Access Compliance Report

Public Rights-of-Way

(Curb Ramps)

Intersection ID: 10024861	Main Street: DESTIN_LN	Cross Street: N/A	Location: SE
ADA ID: B5AE18A91A11	Ramp Type: PerpDiag	Initial Pass/Fail: Fail	Overall Compliance: No
Severity Score: 47.5			
Codes/Mitigation Info/Possible Solution		Field Measurements/Component Compliance

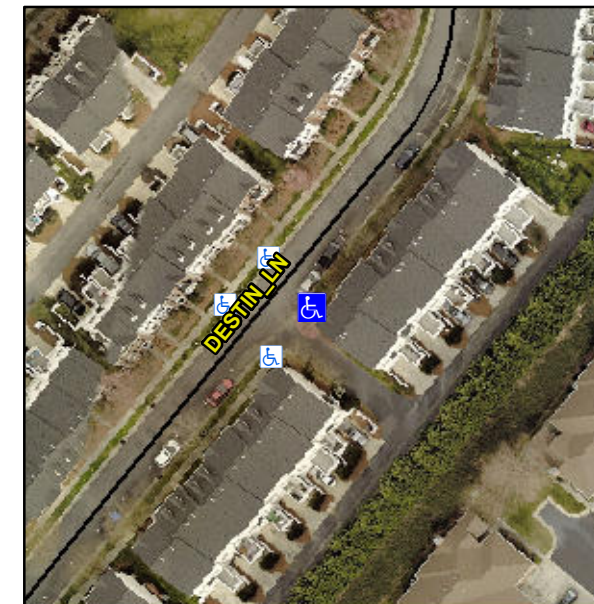
Not Found, R304.5.1, R304.2.2

Compliance	Description	Data	Compliance	Description	Data
N/A	Ramp Length (in)	58.0	No	Ramp Slope (%)	11.3
No	Ramp Width (in)	28.0	Yes	Ramp XSlope (%)	1.3
N/A	Flare Type LT	N/A	N/A	Flare Type RT	N/A
N/A	Flare Slope LT (%)	N/A	N/A	Flare Slope RT (%)	N/A
N/A	Flare Traversable LT?	N/A	N/A	Flare Traversable RT?	N/A
N/A	Landing Length (in)	N/A	N/A	DWS Provided?	N/A
N/A	Landing Width (in)	N/A	N/A	DWS Contrast?	N/A
N/A	Landing Slope (%)	N/A	N/A	DWS Length (in)	N/A
N/A	Landing X Slope (%)	N/A	N/A	DWS Full Width?	N/A
N/A	Landing Curb? (Y/N)	N/A	N/A	DWS Offset (in)	N/A
N/A	Shared Landing?	N/A			
N/A	Gutter Ponding?	N/A	N/A	Gutter Slope (%)	N/A
N/A	Gutter Lip Ht (in)	N/A	N/A	Gutter X Slope (%)	N/A
N/A	Painted X Walk1?	No	N/A	Painted X Walk2?	No
	X Walk 1 Direction	To NW		X Walk 2 Direction	To SW
N/A	X Walk 1 Width (in)	N/A	N/A	X Walk 2 Width (in)	N/A
	X Walk 1 Slope (%)	2.4		X Walk 2 Slope (%)	0.9
	X Walk 1 X Slope (%)	2.5		X Walk 2 X Slope (%)	0.5

Remove & Replace Curb Ramp With Two New Directional Ramps or Equivalent.
